### **COMMENT LETTER – MALIBU CREEK AND LAGOON SEDIMENTATION AND BENTHIC EFFECTS TOTAL MAXIMUM DAILY LOAD**

# Comments of the County of Los Angeles and the Los Angeles County Flood Control District on Malibu Creek and Lagoon TMDL for Sedimentation and Nutrients to address Benthic Impairments

**Figure: Jurisdictional Boundaries in Malibu Creek Watershed.**

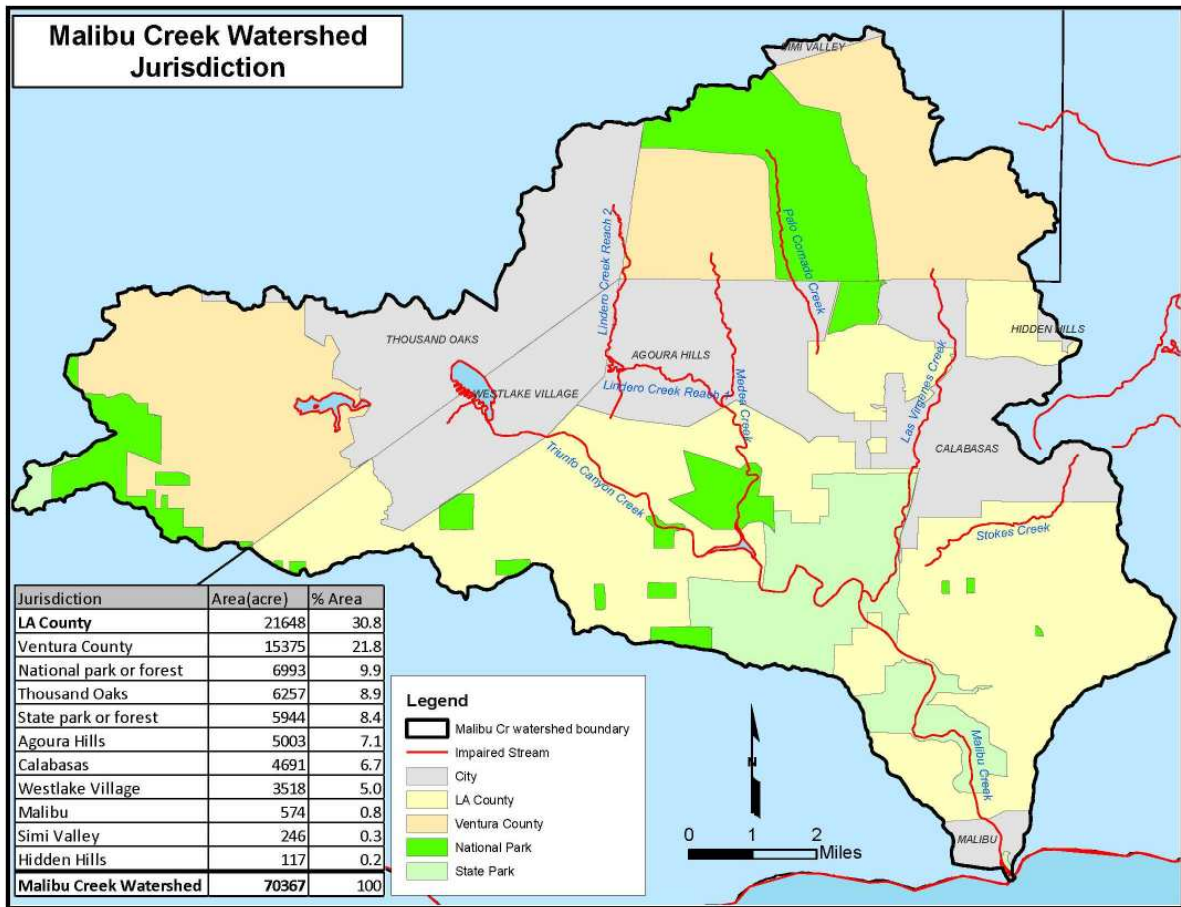
The California Department of Parks and Recreation has land management and ownership responsibility not only for the Malibu Lagoon but also for the State Parks in Santa Monica Mountains that drains to Malibu Creek. The land area under state jurisdiction accounts for about 8.5 percent of the Malibu Creek watershed. Additionally, about 10 percent of the watershed is under the jurisdiction of the National Forest Service. A map that shows the different jurisdictions within the watershed is attached.

Park and forest land management involve various activities including road or trail construction and maintenance, recreational activities, and timber management. As described in the “*Waiver of Waste Discharge Requirements for National Forest System Lands in California*”<sup>[9]</sup>, these activities are known to cause significant sediment and pollutant delivery to streams as well as removal of riparian vegetation resulting in water temperature and habitat changes. The County and cities have no control over the state and federal lands. Therefore, the impact of park and forest management activities on the Malibu Creek should be recognized in the TMDL, and the State and National Parks/Forest Services should be named responsible parties. Also, Figure 4-1 in the draft staff report should be revised to reflect the jurisdictional areas as indicated in the attached map.
